**Amendments agreed to ECE/TRANS/WP.29/GRSP/2011/15
 during the 49th session of GRSP**

**Draft new Regulation on uniform provisions concerning the
 approval of enhanced Child Restraint Systems used onboard
 of motor vehicles**

Figure 0(d)

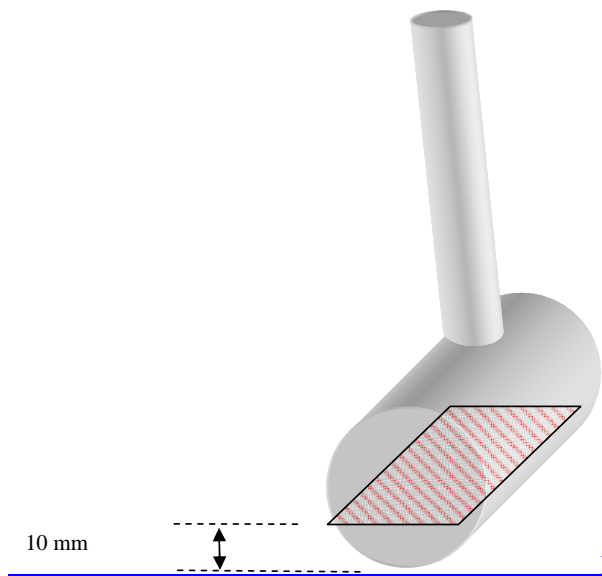
- (j) Adjustment of the support-leg foot to a position beyond the X and Y limits of the support-leg contact volume shall be prohibited (see figure 0(d)).
- (k) The support-leg foot contact volume shall be positioned centrally along the Y axis with respect to the origin as defined in 6.3.5. and shall have a maximum width in this direction of 200 mm.

The support-leg shall be adjustable in order to ensure that the support-leg foot is able to reach at least any height between the upper and the lower height limit in z-direction of the support leg foot assessment volume as specified below (see also figure 3 and 4 of annex 19 of this Regulation). In case of incremental adjustment there shall be no step between two positions of more than 20 mm.

- In length by two planes perpendicular to the x-v-plane and X-Y plane [median longitudinal plane of the child restraint fixture] of the coordinate system defined above, 585 mm and 695 mm apart in X direction from the origin; and

- In height by two planes parallel to the CRF bottom surface, one plane 270 mm and a second plane 525 mm below the CRF bottom surface.

Figure 2 : Side and Front View of the measuring device

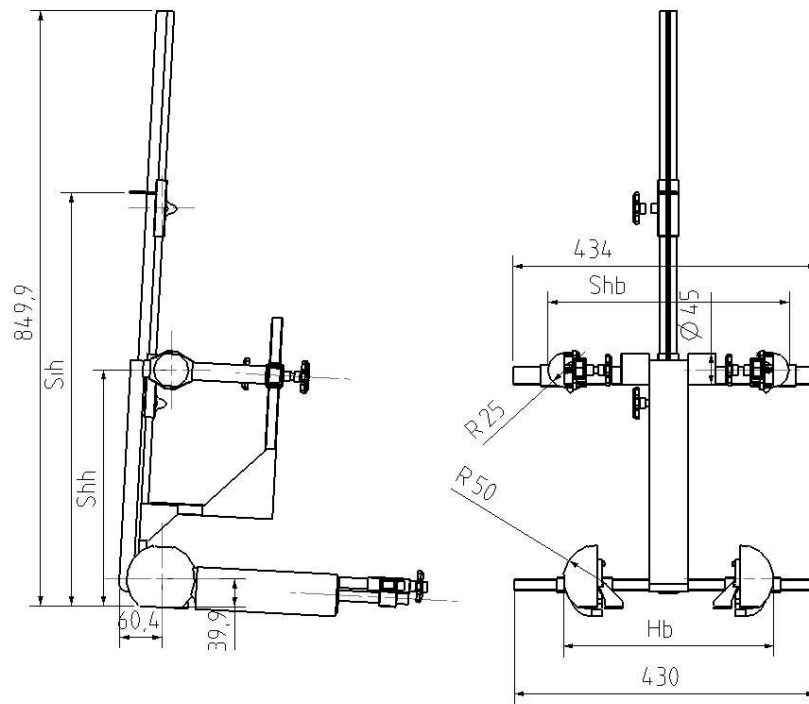
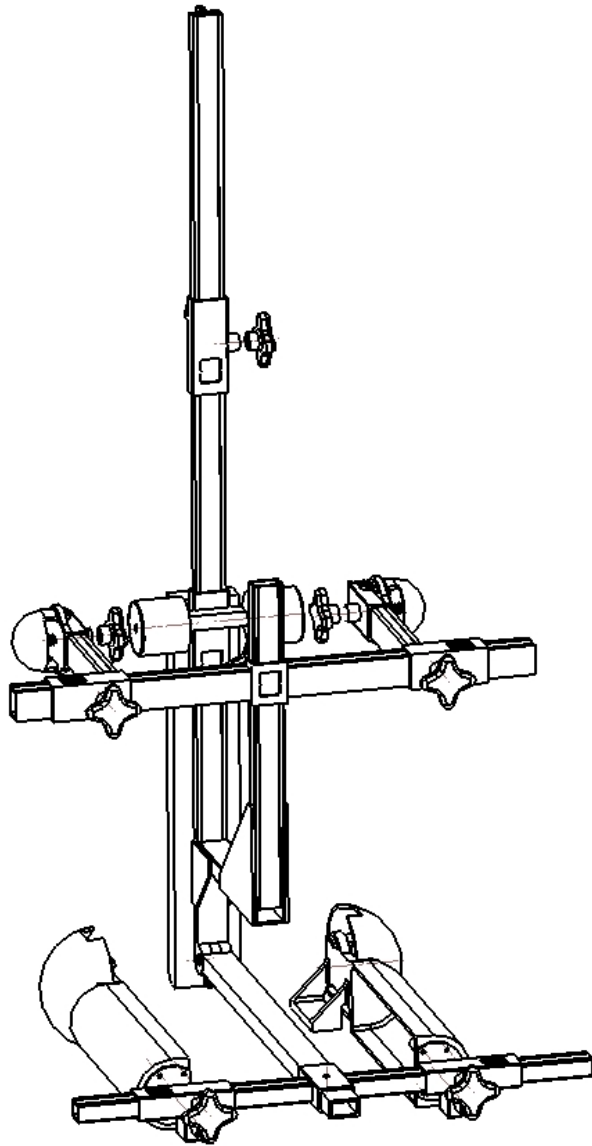
Replace current drawing by the followings:
